Access Compliance Report

Public Rights-of-Way

(Curb Ramps)

Intersection ID: 3226	Main Street: CANBURY_CT	Cross Street: WORSLEY_LN	Location: S
ADA ID: 63104F5F4DA5	Ramp Type: Perp	Initial Pass/Fail: Fail	Overall Compliance: No
Severity Score: 8.75			
Codes/Mitigation Info/Possible Solution		Field Measurements/Component Compliance

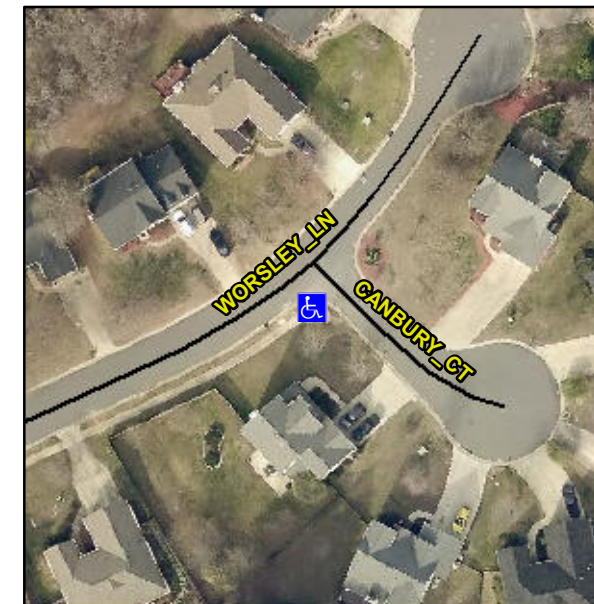
Not Found, R304.5.1

Compliance	Description	Data	Compliance	Description	Data
N/A	Ramp Length (in)	98.0	Yes	Ramp Slope (%)	5.8
No	Ramp Width (in)	47.0	Yes	Ramp XSlope (%)	1.3
N/A	Flare Type LT	N/A	N/A	Flare Type RT	N/A
N/A	Flare Slope LT (%)	N/A	N/A	Flare Slope RT (%)	N/A
N/A	Flare Traversable LT?	N/A	N/A	Flare Traversable RT?	N/A
N/A	Landing Length (in)	N/A	N/A	DWS Provided?	N/A
N/A	Landing Width (in)	N/A	N/A	DWS Contrast?	N/A
N/A	Landing Slope (%)	N/A	N/A	DWS Length (in)	N/A
N/A	Landing X Slope (%)	N/A	N/A	DWS Full Width?	N/A
N/A	Landing Curb? (Y/N)	N/A	N/A	DWS Offset (in)	N/A
N/A	Shared Landing?	N/A			
N/A	Gutter Ponding?	N/A	N/A	Gutter Slope (%)	N/A
N/A	Gutter Lip Ht (in)	N/A	N/A	Gutter X Slope (%)	N/A
N/A	Painted X Walk1?	No	N/A	Painted X Walk2?	N/A
	X Walk 1 Direction	To NE		X Walk 2 Direction	N/A
N/A	X Walk 1 Width (in)	N/A	N/A	X Walk 2 Width (in)	N/A
	X Walk 1 Slope (%)	1.1		X Walk 2 Slope (%)	N/A
	X Walk 1 X Slope (%)	1.0		X Walk 2 X Slope (%)	N/A

Remove & Replace Entire Ramp.
